CITY OF MENIFEE
DEPARTMENT OF PUBLIC WORKS
CONTRACT CHANGE ORDER NO. 08

DATE: 1/18/2024
PROJECT DESCRIPTION: Holland Road Overcrossing at Interstate 215
PROJECT NO: CIP 13-03
CONTRACTOR: Riverside Construction Company

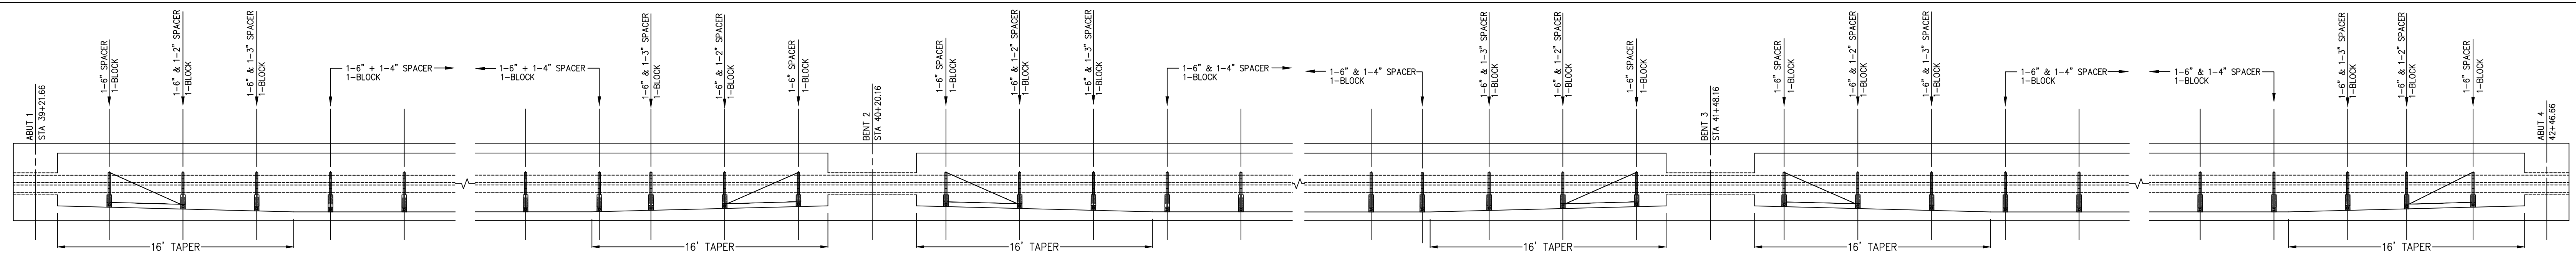
ITEM	DESCRIPTION	U/M	QUANTITY	UNIT PRICE	TOTAL
	Extra Work at Agreed Price				
1	Perform exothermic welding of copper cable to bridge reinforcing steel per attached SCE plan - Structure Bond Connection detail,				\$2,577.22
2	Modify the bridge utility openings and provide additional reinforcing steel				\$6,767.74
TOTAL ESTIMATED PRICE FOR THIS CHANGE ORDER:					\$9,344.96

1. Caltrans requires the Contractor to perform exothermic welding of copper cable to bridge rebar as shown on the attached Southern California Edison's plan - Structure Bond Connection detail for new bridges. This work was not part of the Contract. The Contractor will perform this work as extra work at an agreed price of \$2,577.22.
